Bid Addendum No. 2 for:

MASON TRANSIT AUTHORITY – PARK AND RIDE CONSTRUCTION PROJECT

All Bidders are required to make the following substitutions to the Bid Documents. Below is a description of the revisions made to the Contract Documents.

DRAWING No.: IL-1
SHEET No.: 10 OF 11

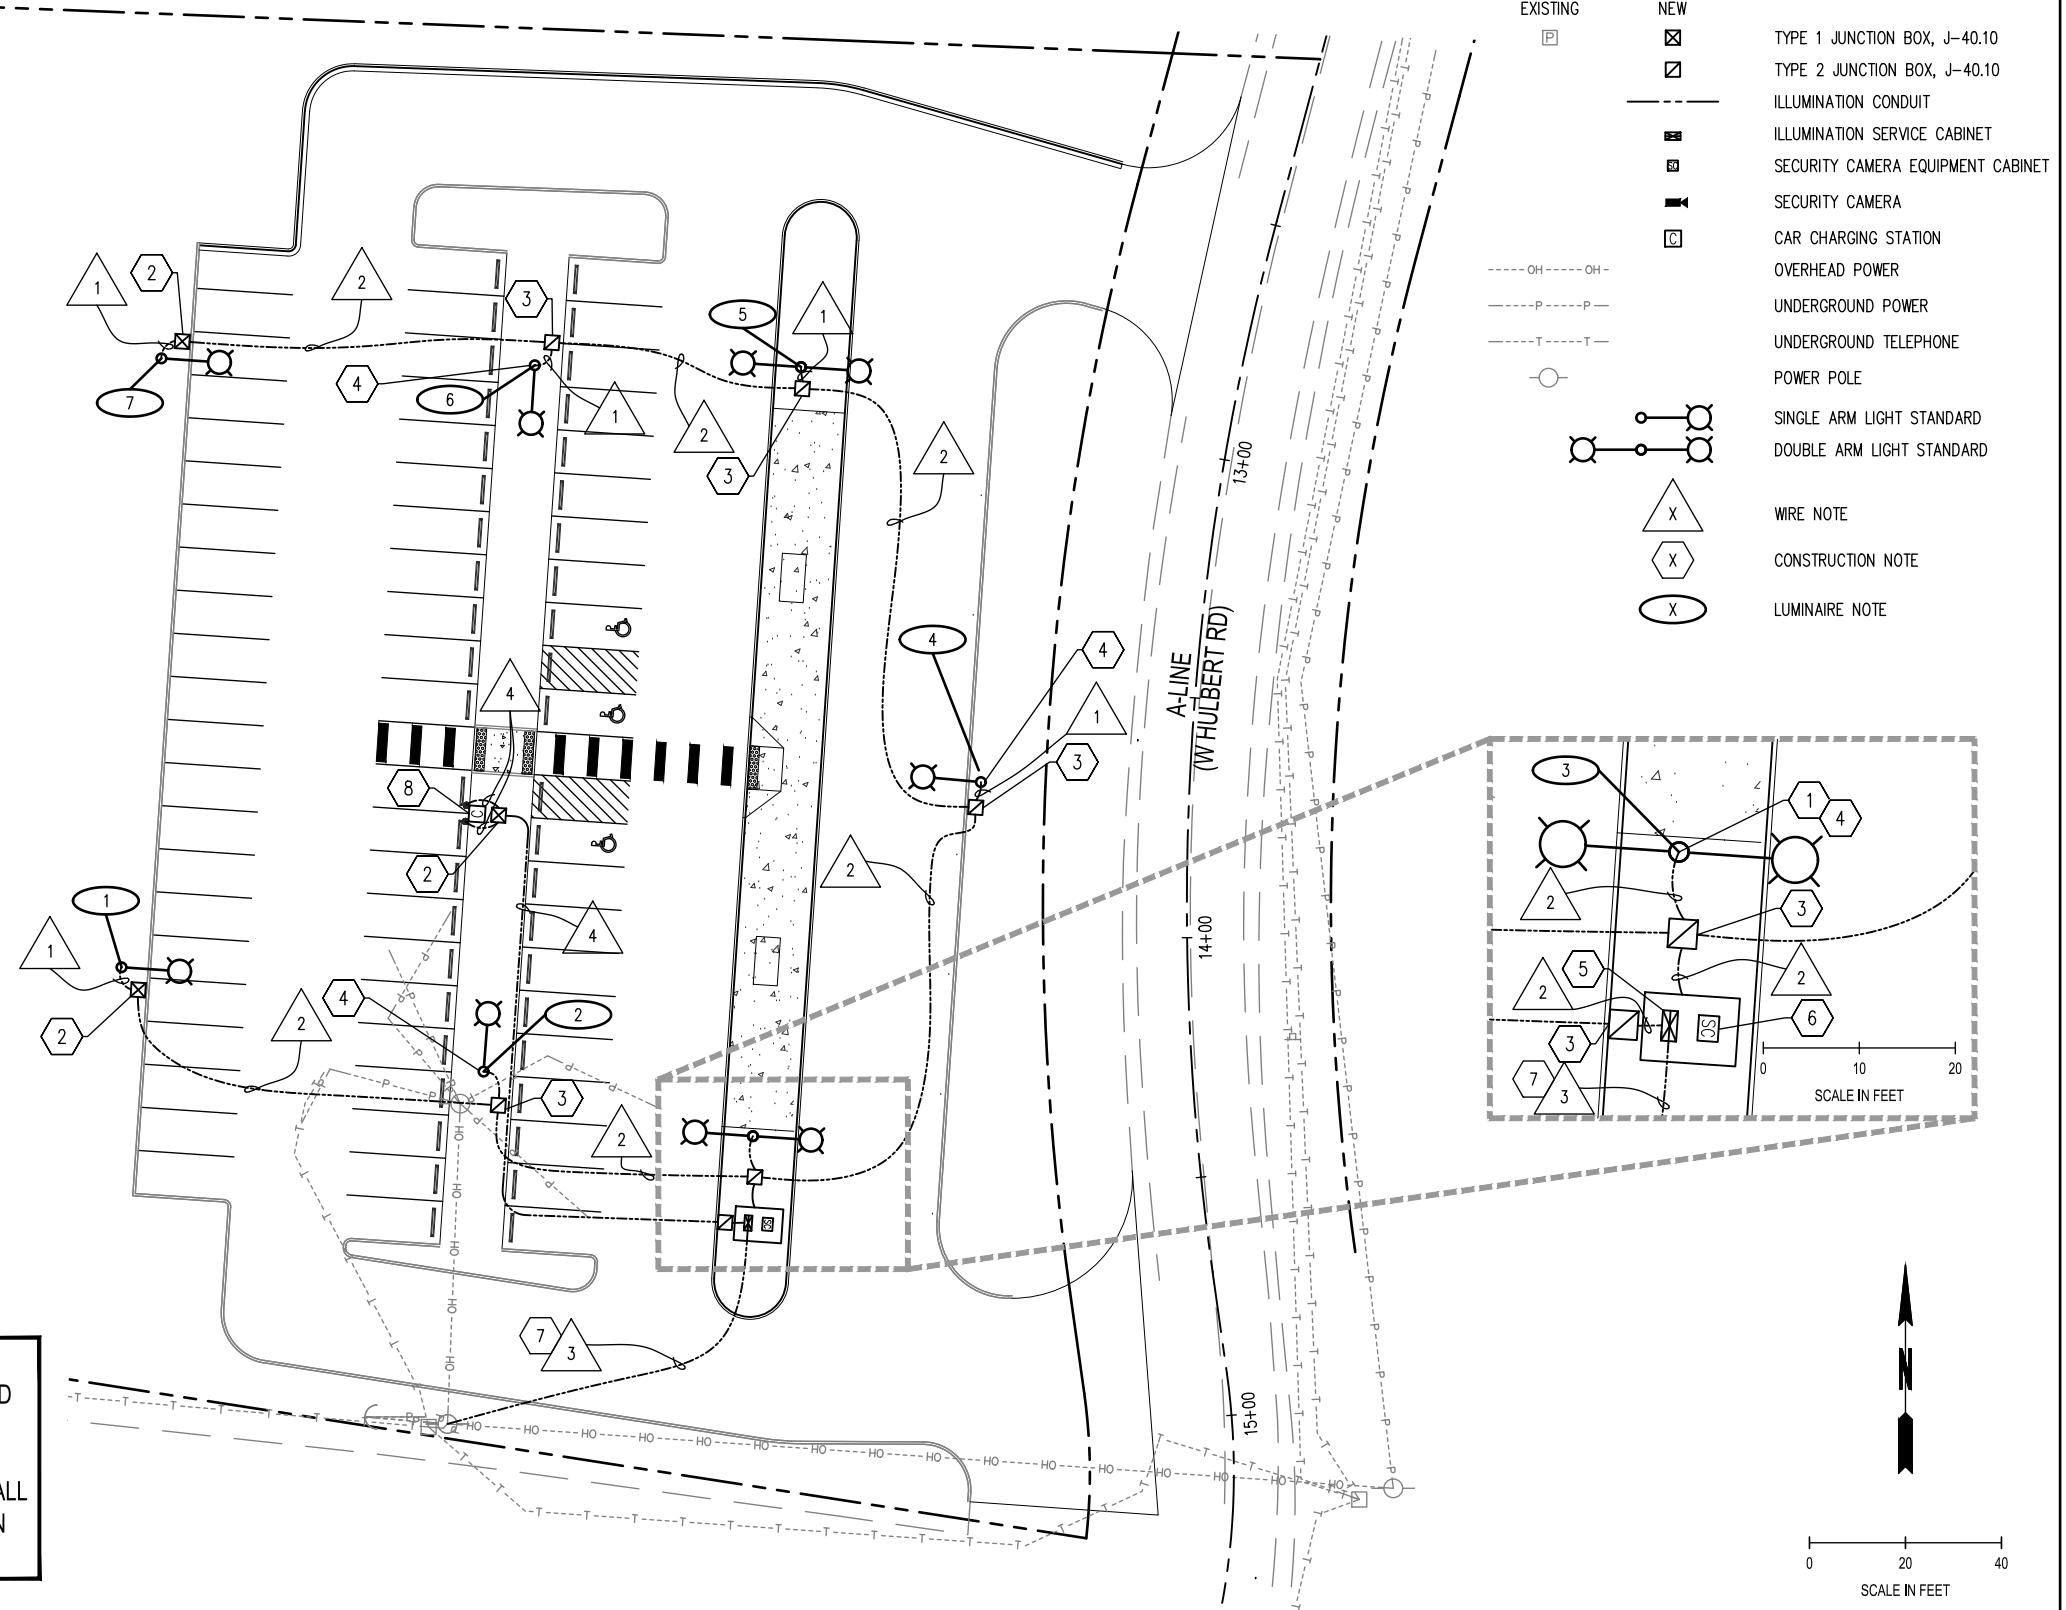
- Sheet II-1: Replace with attachment II-1 to include modified luminaire heads with security camera model.
